Access Compliance Report Public Rights-of-Way (Curb Ramps)

Intersection ID: 44012	Main Street: BRADWELL_DR	Cross Street: LANGHAM_CT	Location: SW
ADA ID: DA456E977DFD	Ramp Type: PerpDiag	Initial Pass/Fail: Fail	Overall Compliance: No
Codes/Mitigation Info/Possible Solution			Field Measurements/Component Compliance

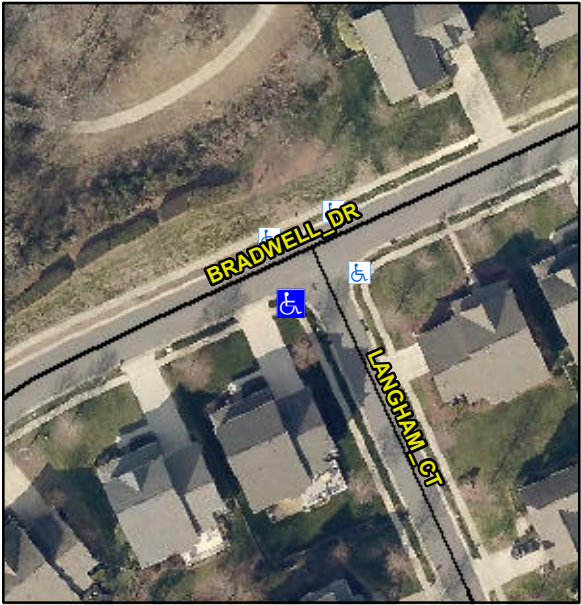
PROW/ADA:
Not Found, R304.5.1, R304.5.3

Compliance	Description	Data	Compliance	Description	Data
N/A	Ramp Length (in)	48.0	Yes	Ramp Slope (%)	5.4
No	Ramp Width (in)	36.0	No	Ramp XSlope (%)	6.7
N/A	Flare Type LT	N/A	N/A	Flare Type RT	N/A
N/A	Flare Slope LT (%)	N/A	N/A	Flare Slope RT (%)	N/A
N/A	Flare Traversable LT?	N/A	N/A	Flare Traversable RT?	N/A
N/A	Landing Length (in)	N/A	N/A	DWS Provided?	N/A
N/A	Landing Width (in)	N/A	N/A	DWS Contrast?	N/A
N/A	Landing Slope (%)	N/A	N/A	DWS Length (in)	N/A
N/A	Landing X Slope (%)	N/A	N/A	DWS Full Width?	N/A
N/A	Landing Curb? (Y/N)	N/A	N/A	DWS Offset (in)	N/A
N/A	Shared Landing?	N/A			
N/A	Gutter Ponding?	N/A	N/A	Gutter Slope (%)	N/A
N/A	Gutter Lip Ht (in)	N/A	N/A	Gutter X Slope (%)	N/A
N/A	Painted X Walk1?	No	N/A	Painted X Walk2?	No
	X Walk 1 Direction	To E		X Walk 2 Direction	To N
N/A	X Walk 1 Width (in)	N/A	N/A	X Walk 2 Width (in)	N/A
	X Walk 1 Slope (%)	2.2		X Walk 2 Slope (%)	1.6
	X Walk 1 X Slope (%)	2.4		X Walk 2 X Slope (%)	2.8

Possible Solutions:
Remove & Replace Curb Ramp With Two New Directional Ramps or Equivalent.
